TECHNICAL BULLETIN  
**Bell Helicopter**

No. 212-08-208

**SUBJECT:** REPLACEMENT OF BLIND RIVETS ON TAILBOOM

**HELICOPTERS AFFECTED:** All Model 212 helicopters with Tailbooms P/N 212-030-100-203 or -229, serial number PZ-1001 through sub.

**Figure 1**  
Affected Rivets  
(Looking Forward and Inboard)

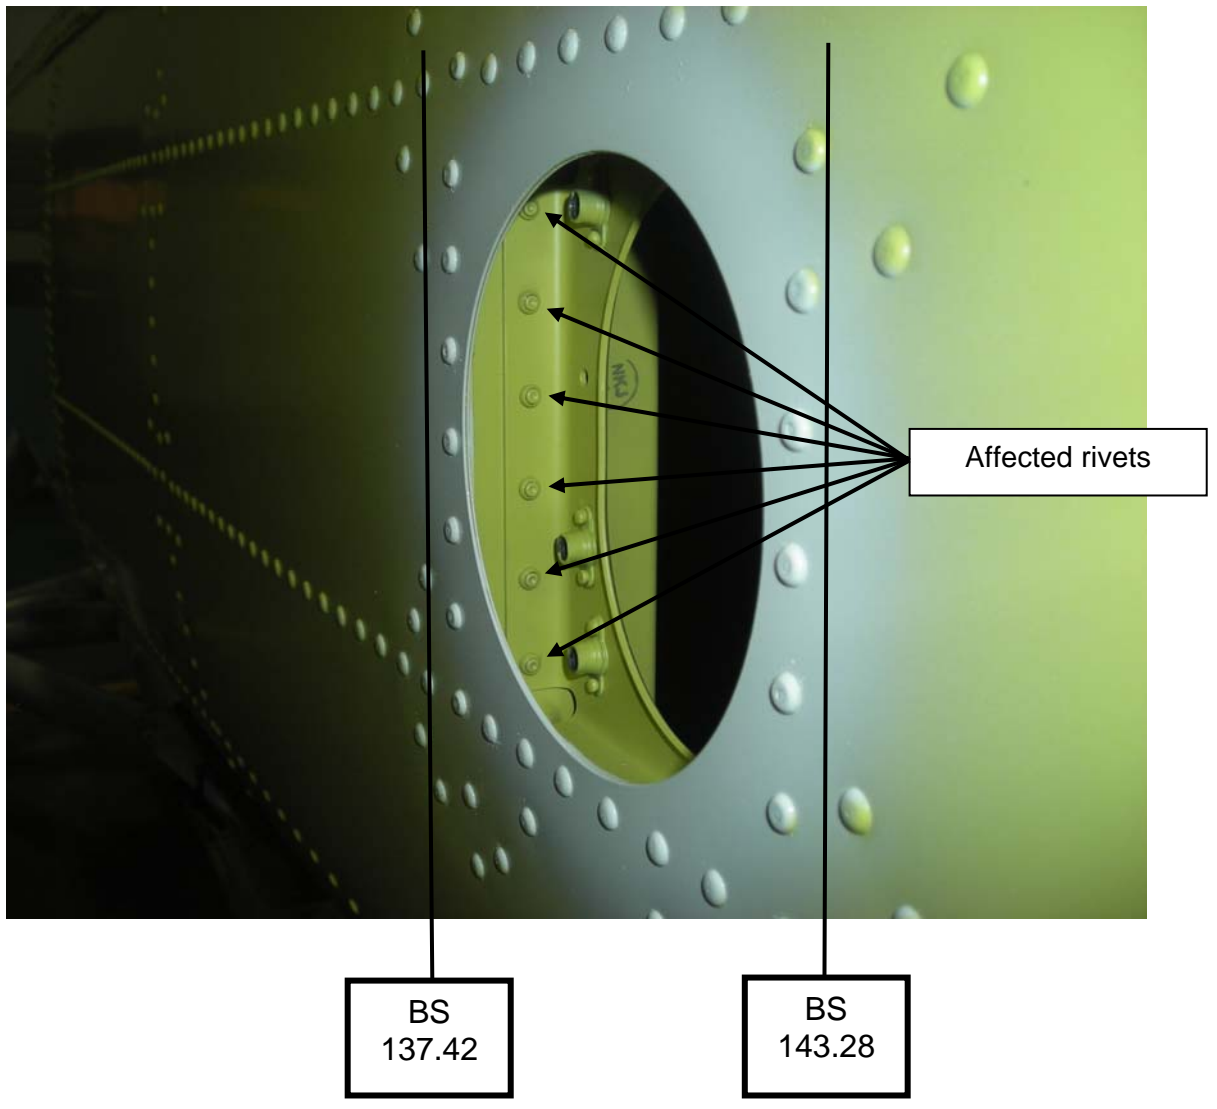
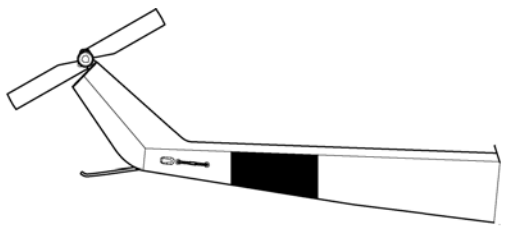
It was recently brought to Bell Helicopter's attention that blind rivets used to install Supports P/N 205-030-889-015 & -016 on some tailbooms may be responsible for cracks on the supports and their attaching structure. Future tailbooms will be built with only solid rivets at this location. This technical bulletin shows how to retrofit existing tailbooms by replacing the existing blind oversize rivets with solid oversize rivets. Only tailboom serial numbers with prefix PZ are affected.

1. Make helicopter ready for maintenance.
2. Confirm presence of blind rivets at the affected location (see Figure 1). If solid rivets are present, this technical bulletin is not required.

- a. There are four rows of rivets affected. Two on each support, of which one is common to the bulkhead at Boom Station (BS) 143.28 and one is common to the rib at BS 137.42. Remove existing blind rivets from one of the rows. Temporarily attach with Cleco fasteners. Wet-install rivets P/N NAS1242AD5-5 in existing holes using sealant (C-392). Refinish.

3. Remove both lower access doors on tailboom belly. Remove both elevators. Remove Elevator Horn. Refer to Maintenance Manual.
4. Replace rivets (vertical rows only) attaching Supports P/N 205-030-889-015 & -016 as follows (refer to Figure 1):

- b. Repeat for other three rows (24 rivets total).
5. Reinstall Elevator Horn in accordance with Maintenance Manual.
6. Reinstall both Elevators in accordance with Maintenance Manual.
